MEMO

TO: Kerry Wynne **DATE:** 9th February 2023
FROM: Justin Courtier/Phil Read **PROJECT NO.:** J000502
COPY: Harrison Hitchins
SUBJECT: Response to s92 Further Information Request – Ropata Village (Rev A)

Figure 1: Proposed Treatment Device Locations

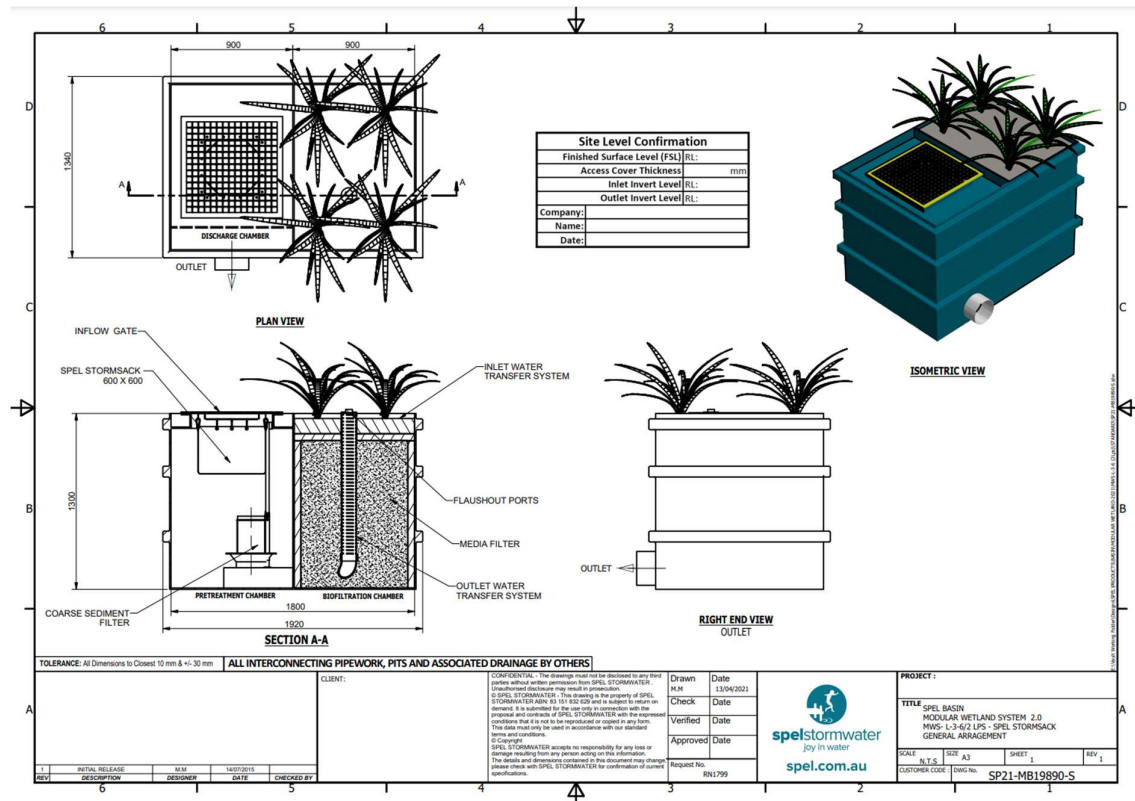
"Could the engineers confirm / demonstrate that there is enough land set aside for stormwater treatment, and also that the proposed stormwater network allows for treatment of stormwater from road areas prior to mixing with 'clean' stormwater from roofs and/or landscaped areas?"

- An area has been set aside for a rain garden adjacent to Unit 14, of approximately 25m² in size. This area can receive runoff from the entry and carpark access (~350m²). The 25m² rain garden is able to treat ~415m² of runoff area and therefore is of a sufficient size to treat runoff from the above sub catchment.
- The remaining road area consists of the main carpark (~300m²), which cannot be directed to the 25m² raingarden due to the proposed landform. We propose to treat this area using a separate proprietary rain garden (SPeLBasin or similar – refer to Figure 2 below). The approximate size and location of this is shown below in Figure 1.
- Detailed rain garden design to be undertaken at the building consent stage.
